DEVELOPMENT REVIEW BOARD
SUPPLEMENTAL SUBMITTAL

PROJECT NO. PR-2021-006070

Re: Westpointe40 North Site Plan DRB Comment Responses (PR-2021-006070)

This memo outlines the responses and changes made to the site plan for the proposed 150K spec industrial building at Westpointe40 based on the comments received and reviewed at the December 15, 2021 DRB meeting.

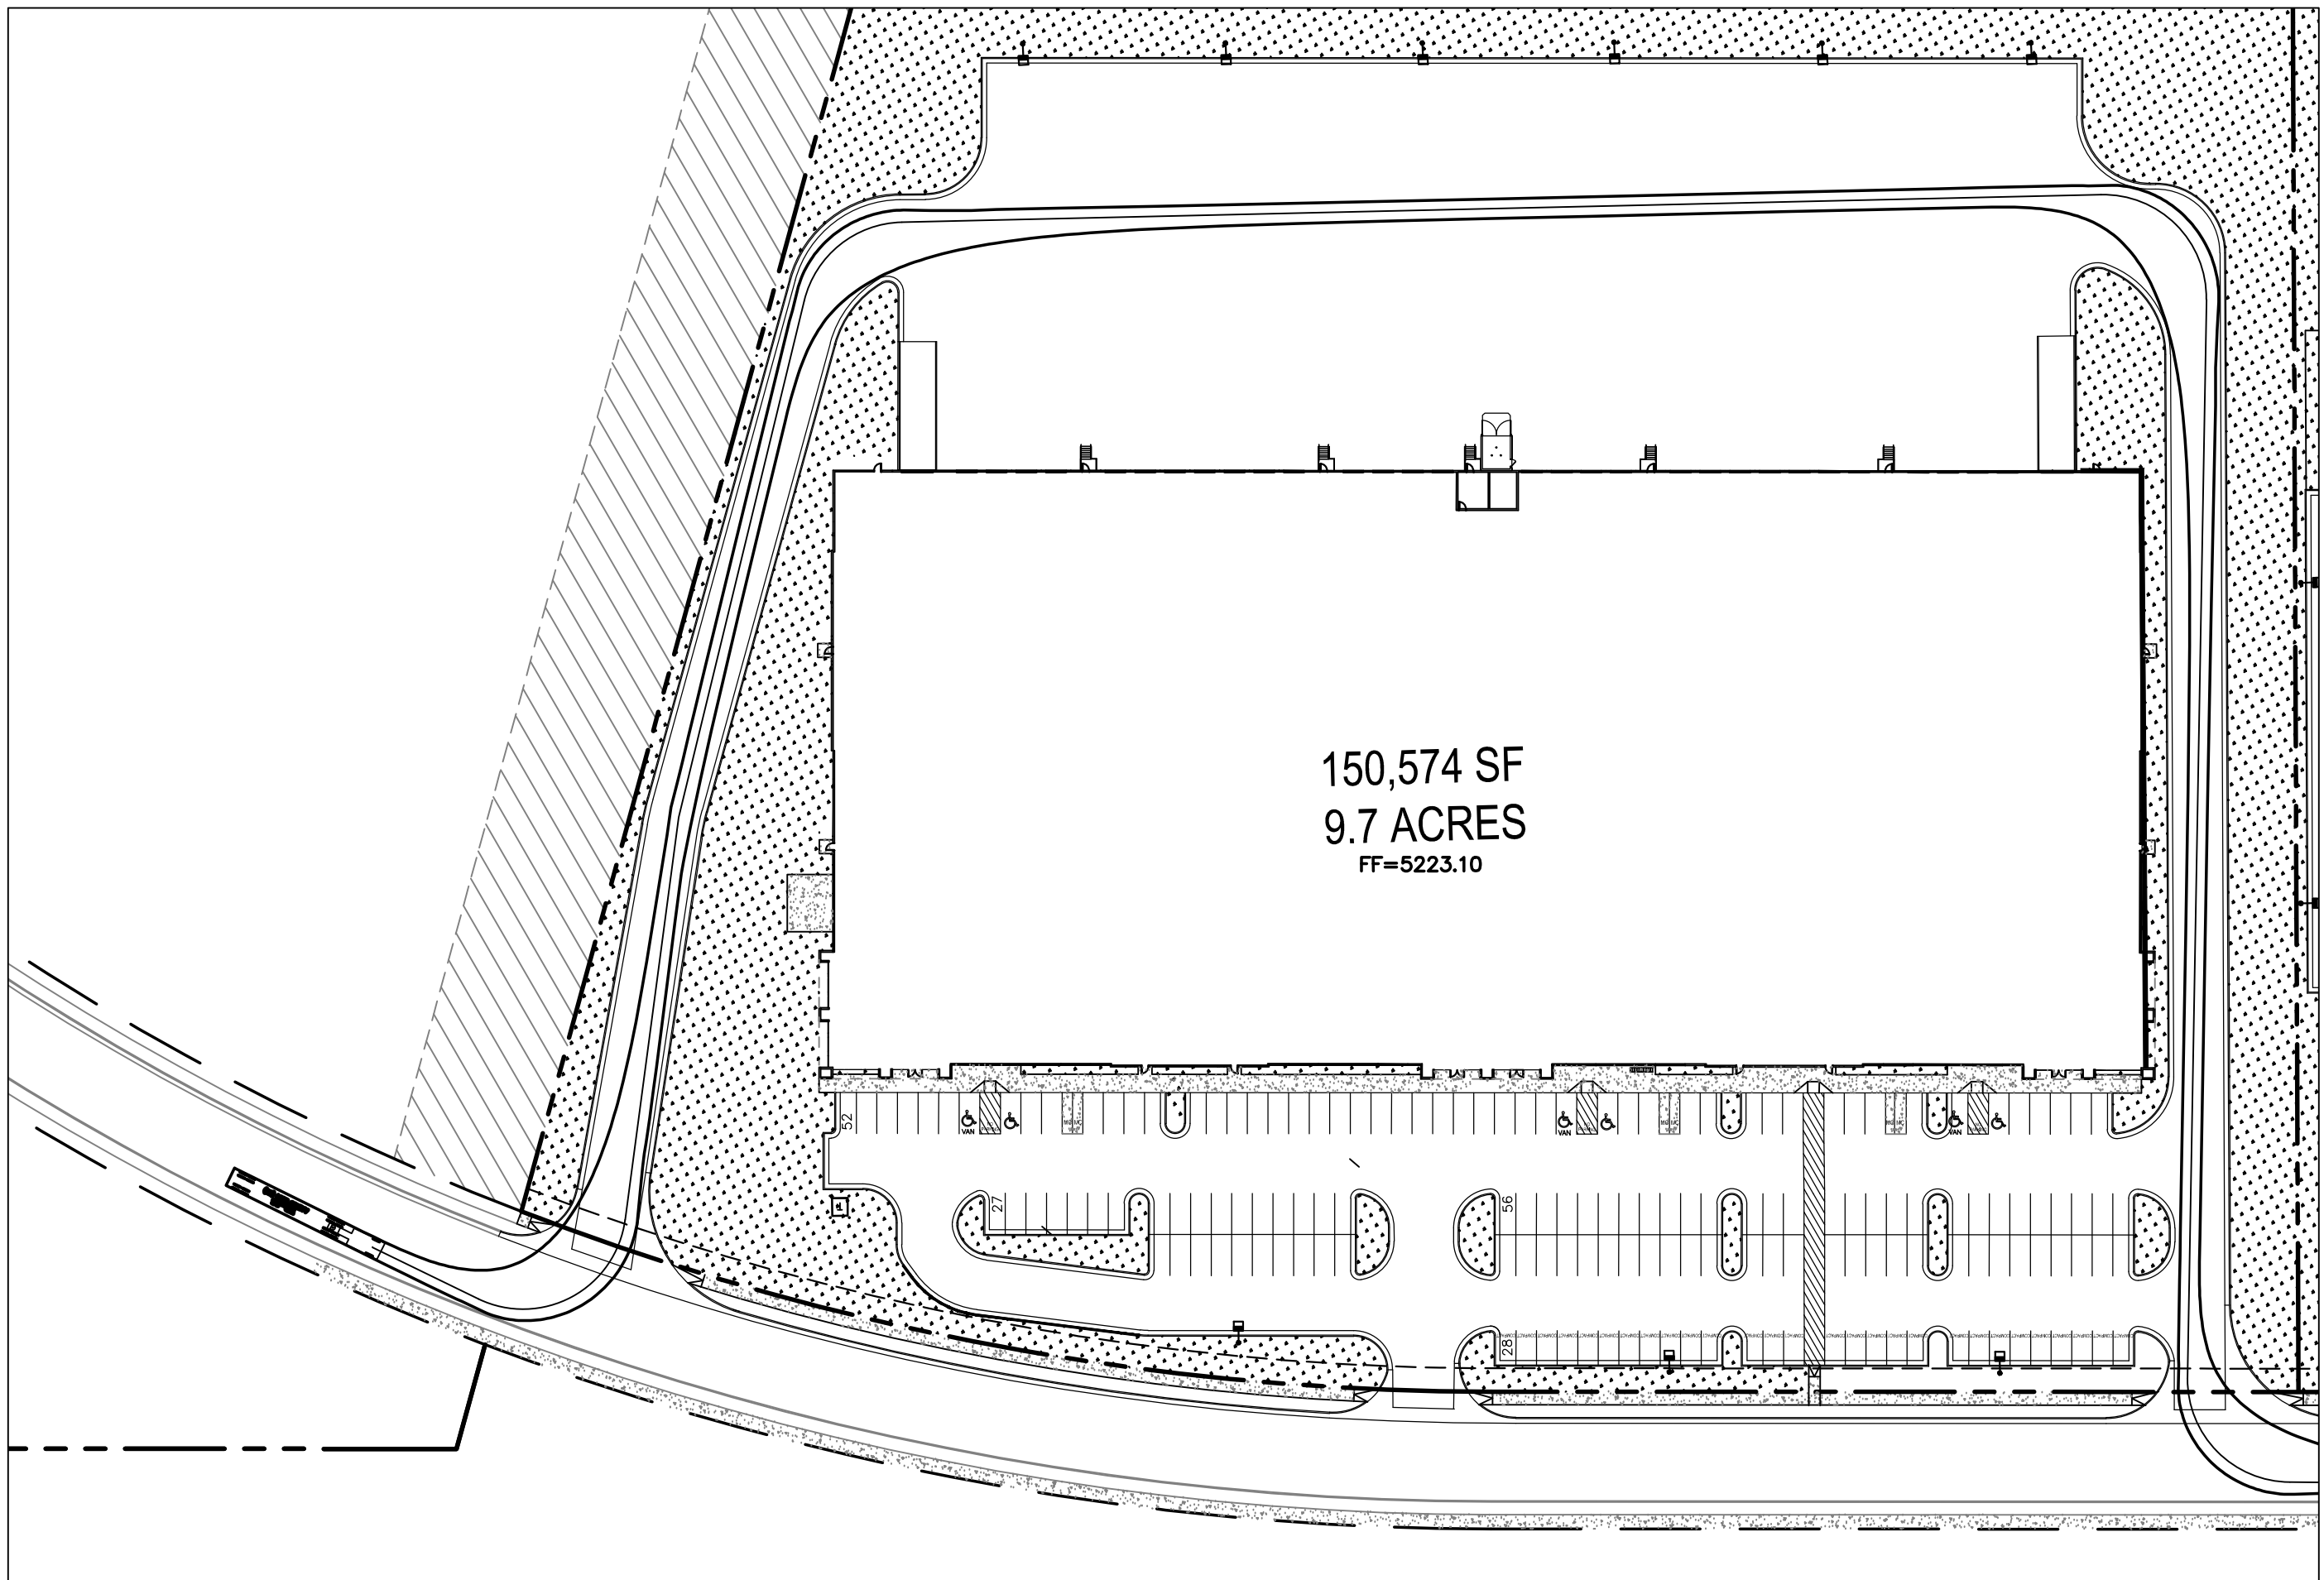
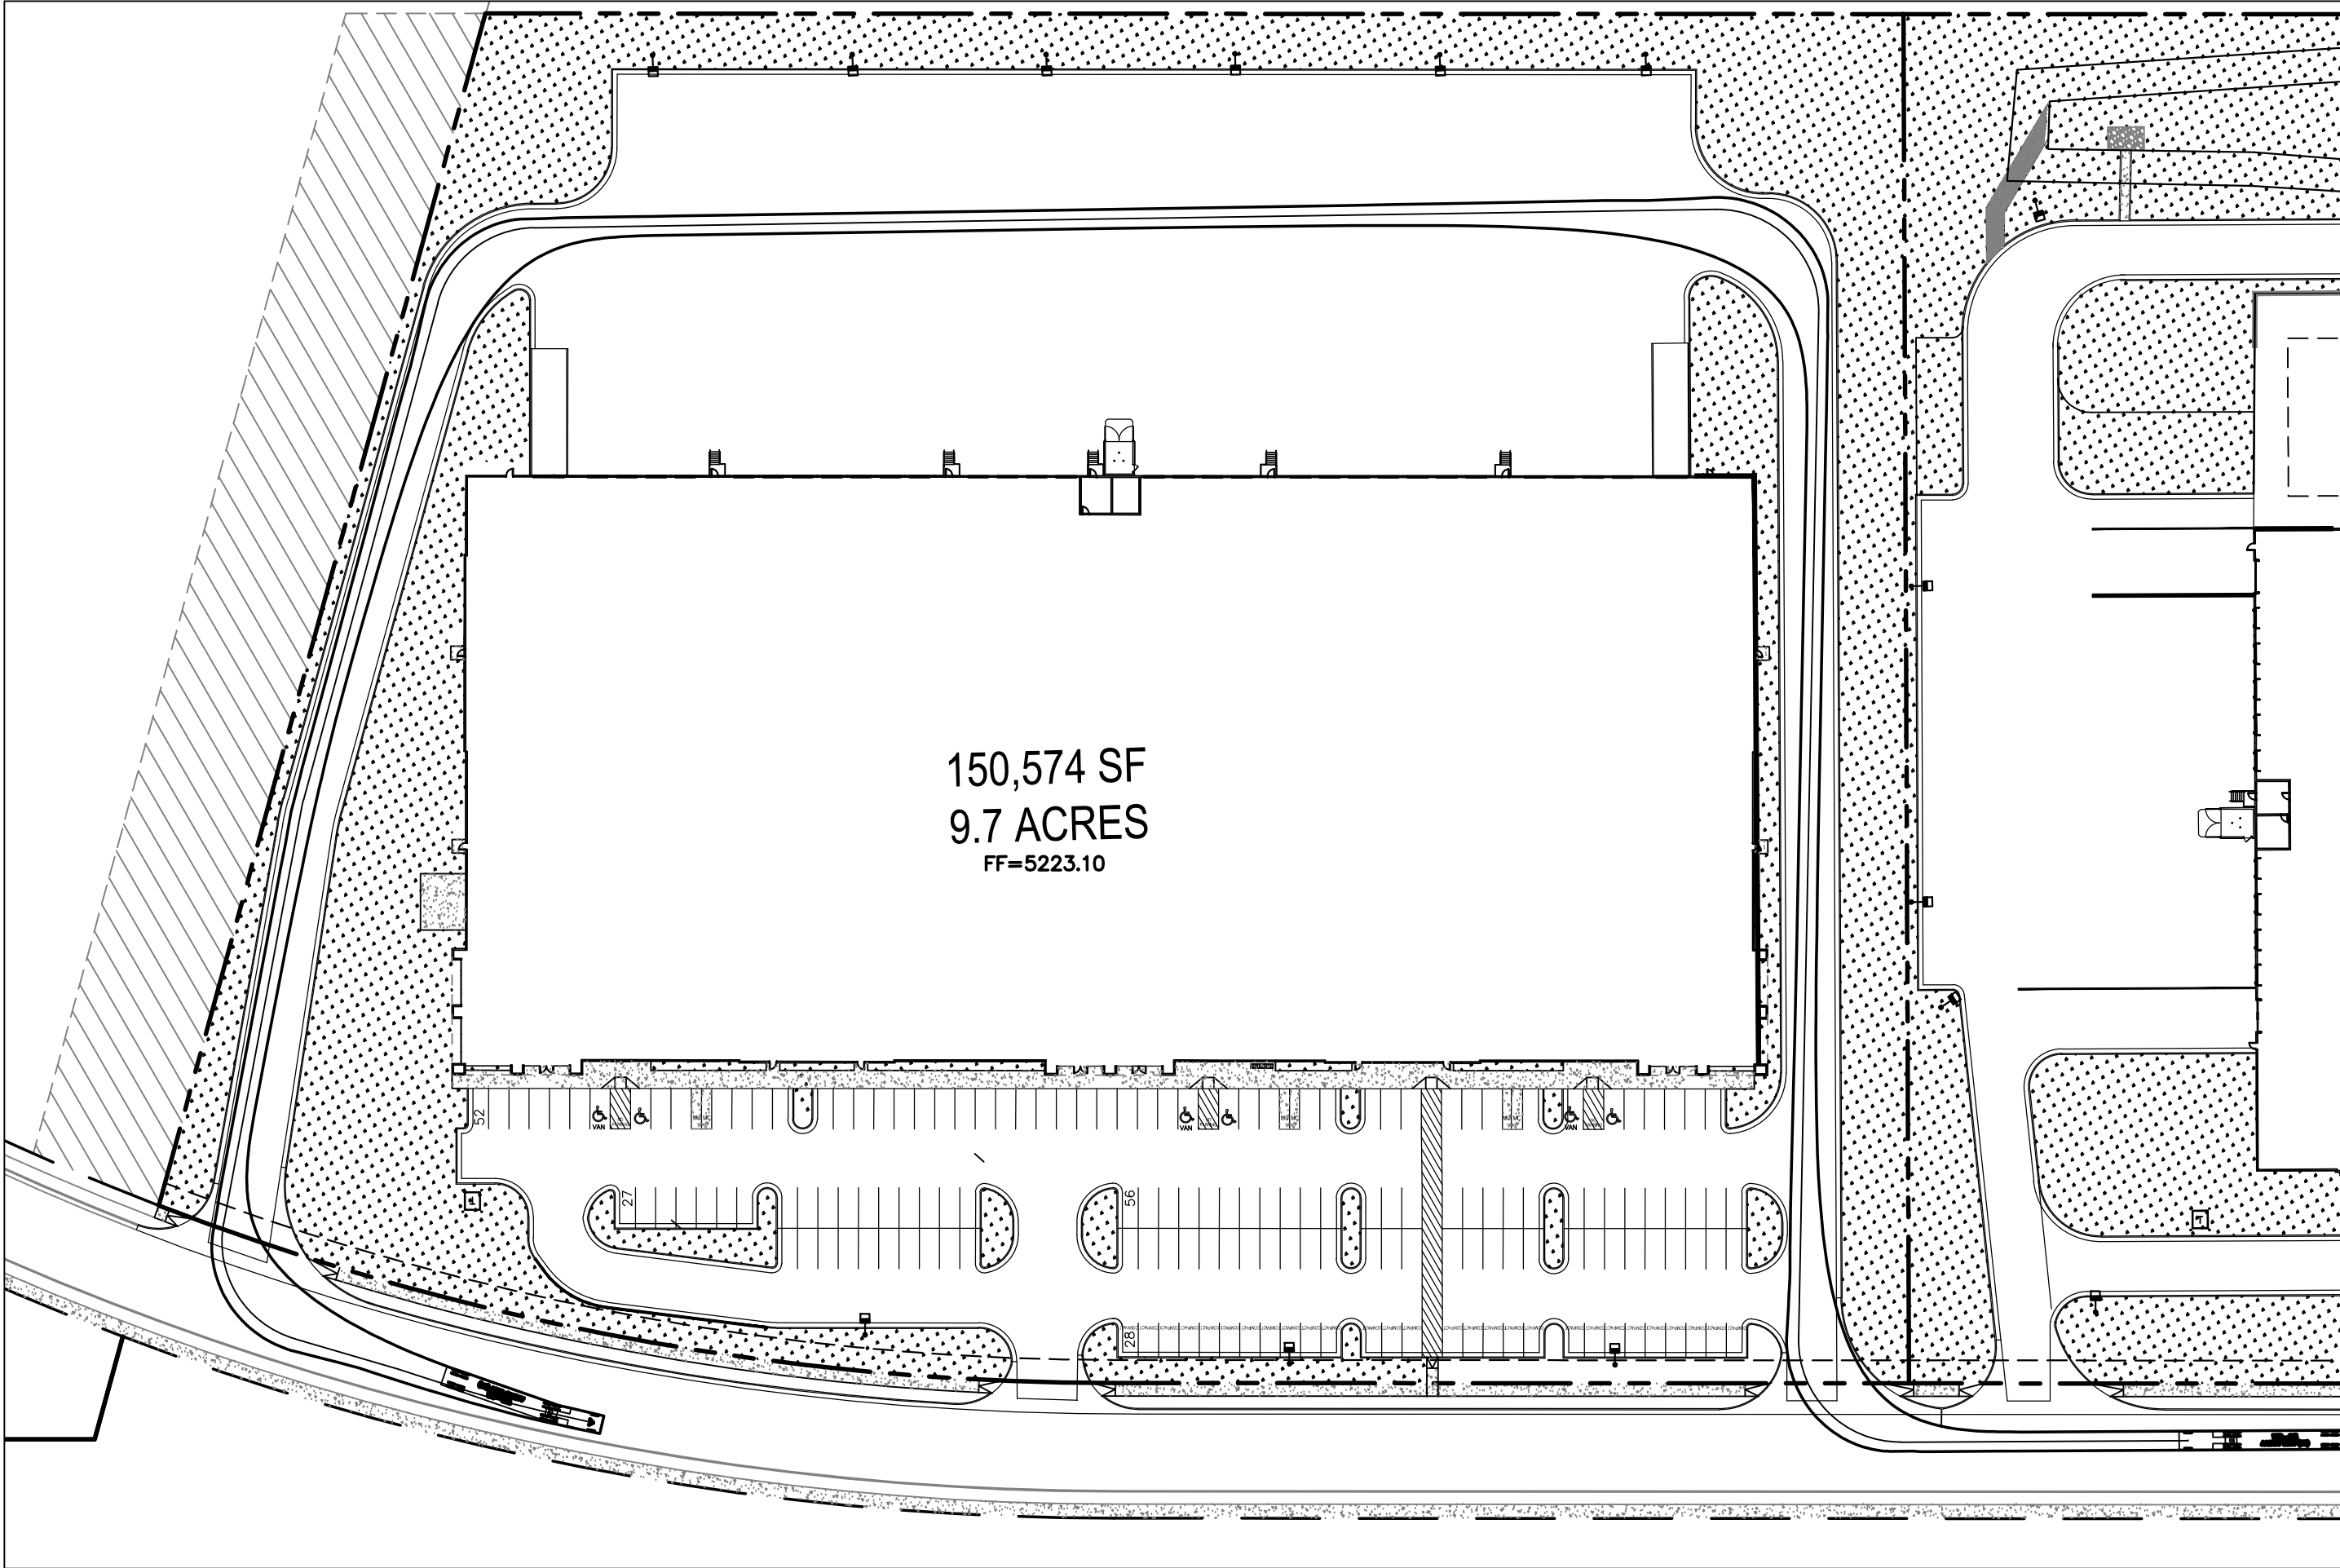
1. Based on the turning template provided, there is minor overlap between truck turning movements and the curb. Radii appear to need adjustment at the 90-degree bends, and some minor overlap is shown close to one of the entrances.

- *The radii have been adjusted slightly on the Site Plan and updated turning template exhibits are provided.*
2. On the cross-section shown, the minimum width for a bike lane is 5 feet without the curb, and the minimum required vehicular lane width is 11 feet. Make any adjustments as needed.
